**RE: Application 2015/5847/P - 66 Fitzjohns Avenue**

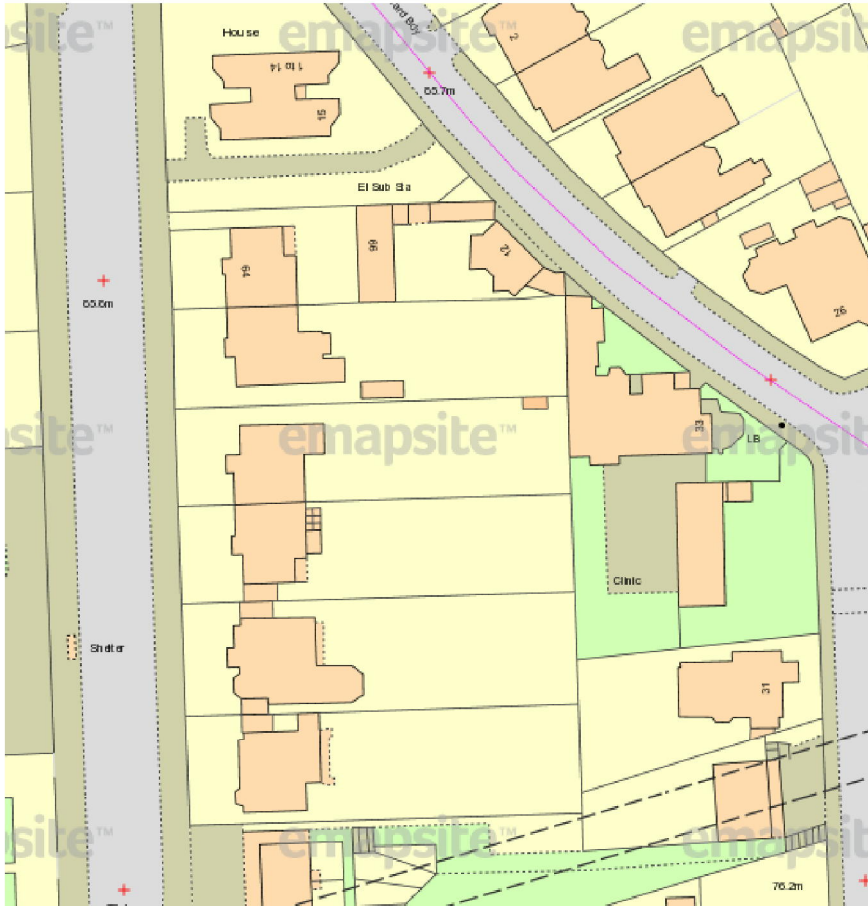
1) Firstly we are deeply concerned about the effect the proposed development will have on the lower ground flat and patio at 64 Fitzjohns Avenue which is immediately in front of the proposed house at 66 Fitzjohns Avenue. The rear patio of #64 abuts the site and would be adjacent (the party structure) to the current proposed basement construction.

My main comment is regarding the scale of the proposed basement and I think you are right in stating that a site inspection is necessary to really appreciate the back land nature of this site and I sincerely hope you are able to visit. The current proposed basement literally will be under the whole site area, touching all neighbouring boundaries to the North, East, West and South. As I stated we are developers and routinely work within Camden and I am somewhat surprised that this revised scheme is being considered for approval. The proposed basement plan incorrectly states that "the basement takes up 39% of the total garden area **up to the pavement**". Please see the attached marked up drawing showing the area of the drive up to the pavement the architect is claiming is garden. To us this is ridiculous. In fact the proposal will take up almost 80% of the garden. Notwithstanding the fact that part of the area they are claiming is garden is actually the parking area for two cars. Over and above this, there is no way the current proposal would comply with any of the CPG4 policy guidance as copied below including item 2.27 and the current proposed skylights in the front garden.

65 FITZJOHNS AVENUE  
 EXISTING FRONT ELEVATION

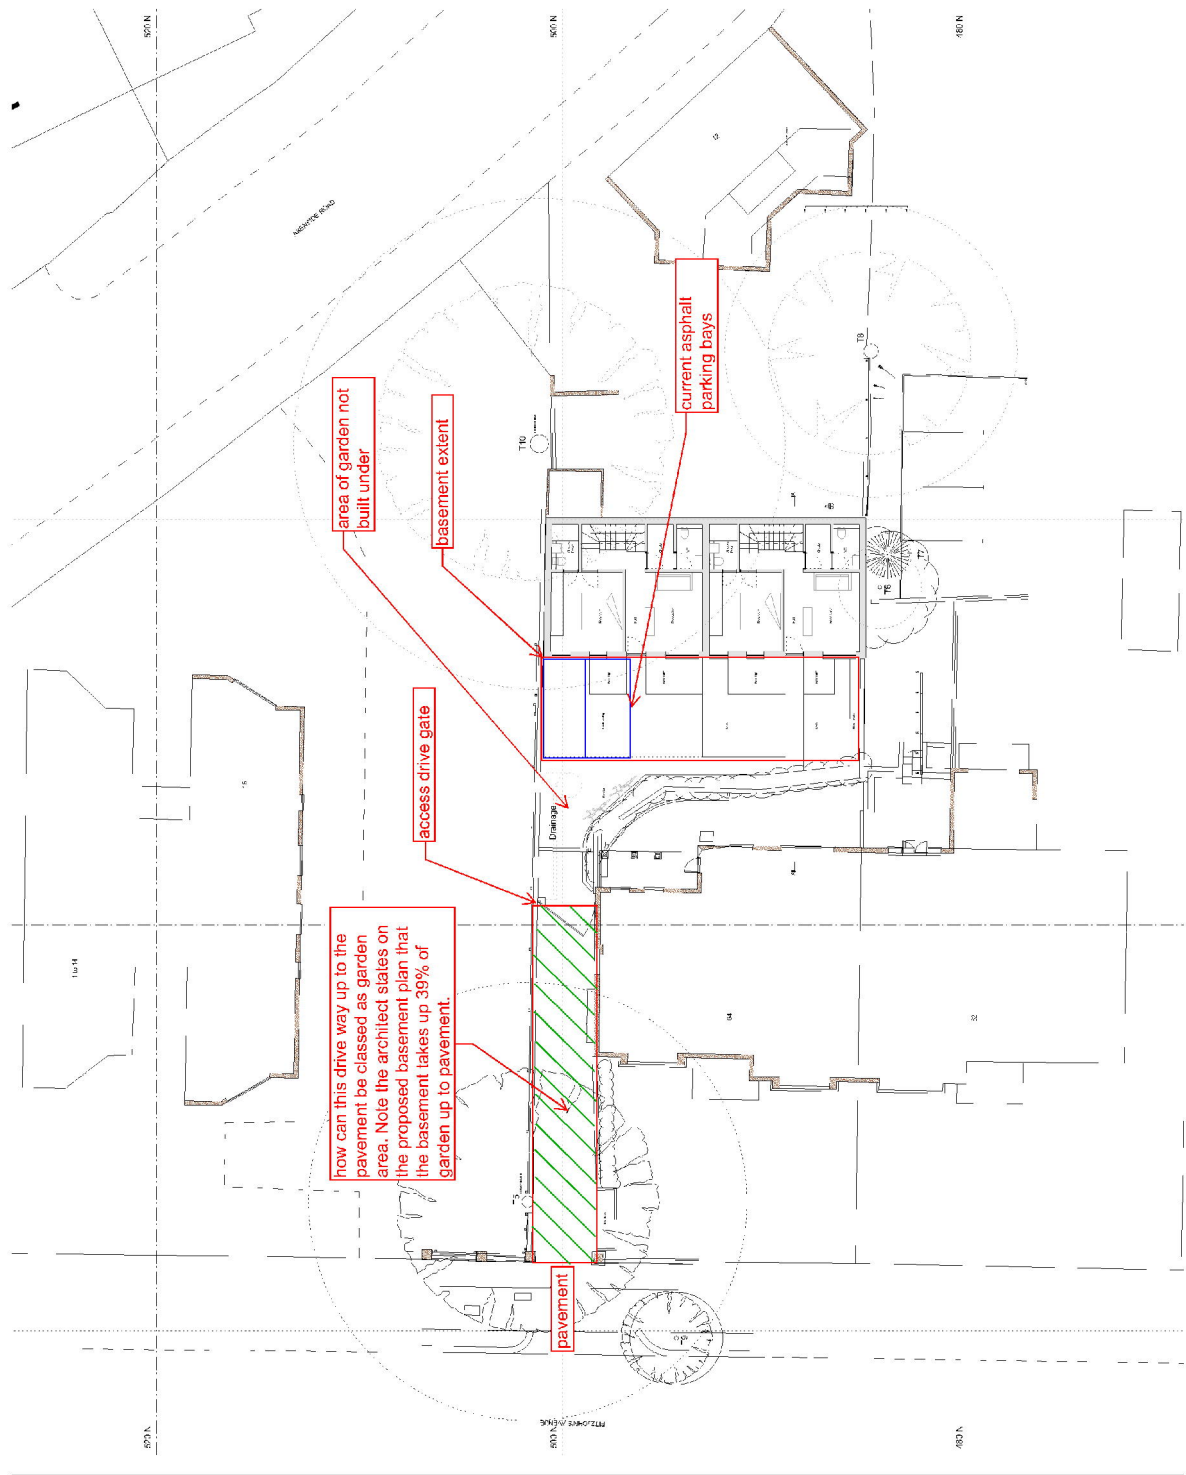
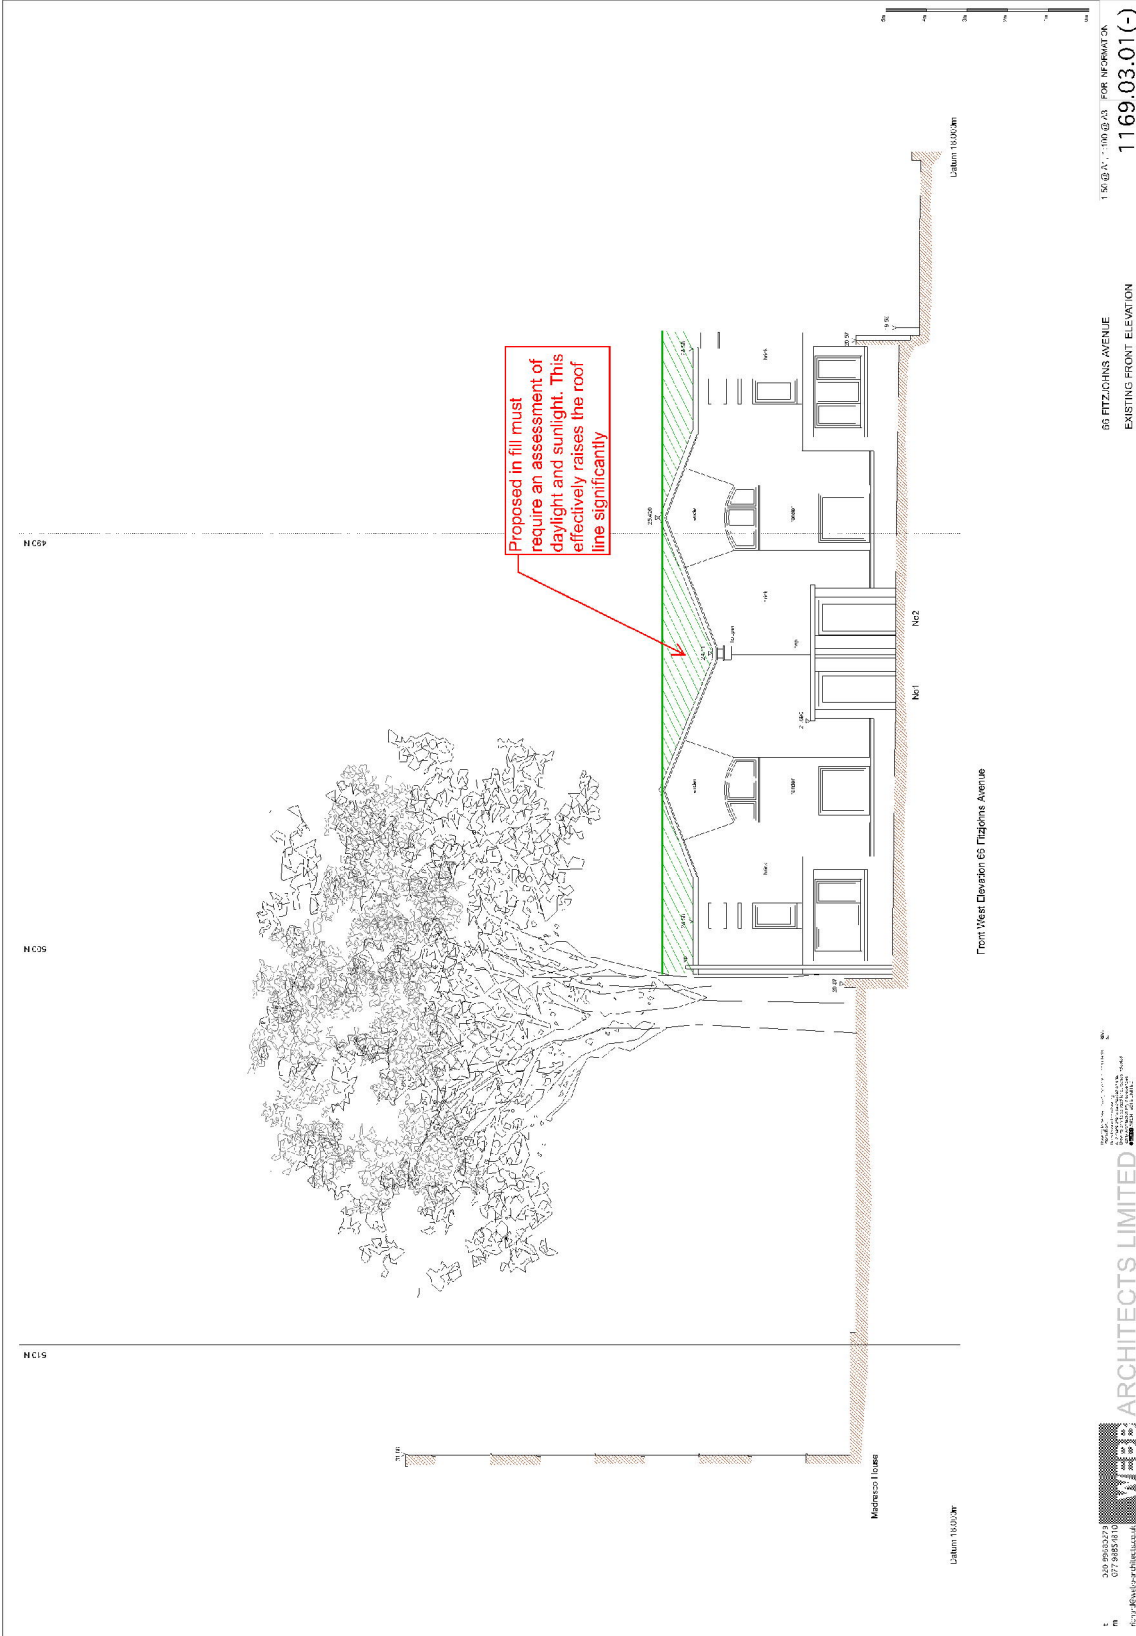
2) I would also point out that the overall height of the roof is being increased and I cannot understand why a daylight and sunlight report is not available for inspection (see attached roof height drawing). Surely the close proximity to the rear of #64 would necessitate a review of this? Any increase in the effective height of the roof of the proposed building will have a potential negative effect on the daylight and sunlight to the lower floors of #64. You can also see from the o/s map below that the usual rhythm of the properties along Fitzjohns Ave is large gardens and 64 is the only one that has had a building built in the rear garden. To allow an increase in the height and massing on such a small site is in our view wholly unacceptable.
